Access Compliance Report

Public Rights-of-Way

Intersection ID: 30444	Main Street: NANNYBERRY_LN	Cross Street: TABCAT_CT	Location: SE
ADA ID: B6BFE7F0698B	Ramp Type: PerpDiag	Initial Pass/Fail: Fail	Overall Compliance: No
Severity Score: 21.25			
Codes/Mitigation Info/Possible Solution		Field Measurements/Component Compliance

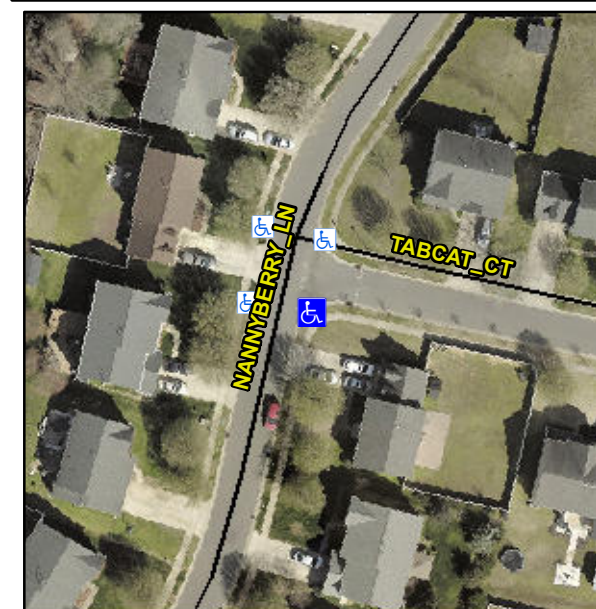
R304.5.1, R304.5.3

Compliance	Description	Data	Compliance	Description	Data
N/A	Ramp Length (in)	47.0	Yes	Ramp Slope (%)	5.6
No	Ramp Width (in)	45.5	No	Ramp XSlope (%)	5.1
N/A	Flare Type LT	N/A	N/A	Flare Type RT	N/A
N/A	Flare Slope LT (%)	N/A	N/A	Flare Slope RT (%)	N/A
N/A	Flare Traversable LT?	N/A	N/A	Flare Traversable RT?	N/A
N/A	Landing Length (in)	N/A	N/A	DWS Provided?	N/A
N/A	Landing Width (in)	N/A	N/A	DWS Contrast?	N/A
N/A	Landing Slope (%)	N/A	N/A	DWS Length (in)	N/A
N/A	Landing X Slope (%)	N/A	N/A	DWS Full Width?	N/A
N/A	Landing Curb? (Y/N)	N/A	N/A	DWS Offset (in)	N/A
N/A	Shared Landing?	N/A			
N/A	Gutter Ponding?	N/A	N/A	Gutter Slope (%)	N/A
N/A	Gutter Lip Ht (in)	N/A	N/A	Gutter X Slope (%)	N/A
N/A	Painted X Walk1?	No	N/A	Painted X Walk2?	No
	X Walk 1 Direction	To NE		X Walk 2 Direction	To NW
N/A	X Walk 1 Width (in)	N/A	N/A	X Walk 2 Width (in)	N/A
	X Walk 1 Slope (%)	0.9		X Walk 2 Slope (%)	0.5
	X Walk 1 X Slope (%)	0.3		X Walk 2 X Slope (%)	1.4

Remove & Replace Curb Ramp With Two New Directional Ramps or Equivalent.
